**BRIEF OPINION**  
**ON THE**  
**TEPCO PLAN TO FLOOD THE PRIMARY CONTAINMENT OF UNIT 1,**  
**FUKUSHIMA DAI-ICHI**

**CLIENT: GREENPEACE GERMANY**

**REPORT REF N° R3197-A1**

# TEPCO PLAN TO FLOOD THE PRIMARY CONTAINMENT OF UNIT 1, FUKUSHIMA DAI-ICHI

FIGURE 2C CONTAINMENT FLOODING ARRANGEMENTS

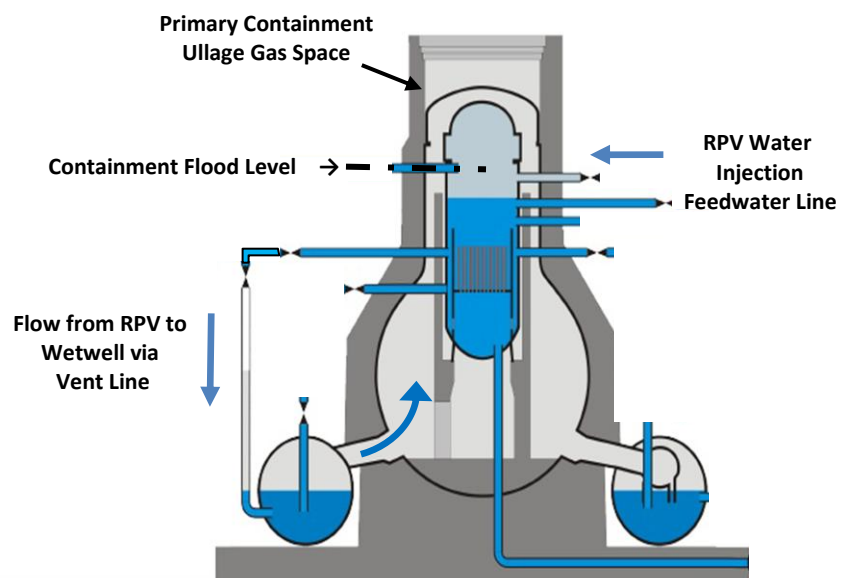
**Extant Condition of Unit 1 Reactor and Primary Containment:** At this time freshwater is being injected directly into the RPV via one of the available entry routes (probably the feedwater inlet – see [FIGURES 2C](#) and [3](#)) at a quantity and rate believed sufficient to maintain the RPV fuel temperature within tolerable limits, although the higher sections of the fuel bundles remain exposed.<sup>8</sup> If the RPV feedwater inlet is in use for water injection, then cooling water is first channelled into the feedwater inlet annulus and not directly circulating within the fuel core itself, possibly giving rise to a high differential between the monitored temperatures of the RPV outer casing and the inferred fuel temperatures within the RPV.

- According to the TEPCO flooding scheme,<sup>13</sup> a link between the coolant in the RPV and the primary circuit is to be established – the coolant water injected into the RPV via the open feedwater line is to flow through and around the damaged fuel in the RPV, and then into the wetwell and drywell cavities.

- This arrangement means that a greater volume of water will be at risk of fission product contamination and release to the environment should the containment fail; and also

- the linking and flow arrangement removes the first containment barrier (the RPV) of what is presently a two-barrier containment system, that is reducing the enclosure to the single barrier of primary containment, which it has not been possible to inspect to determine its resilience against further seismic loading.
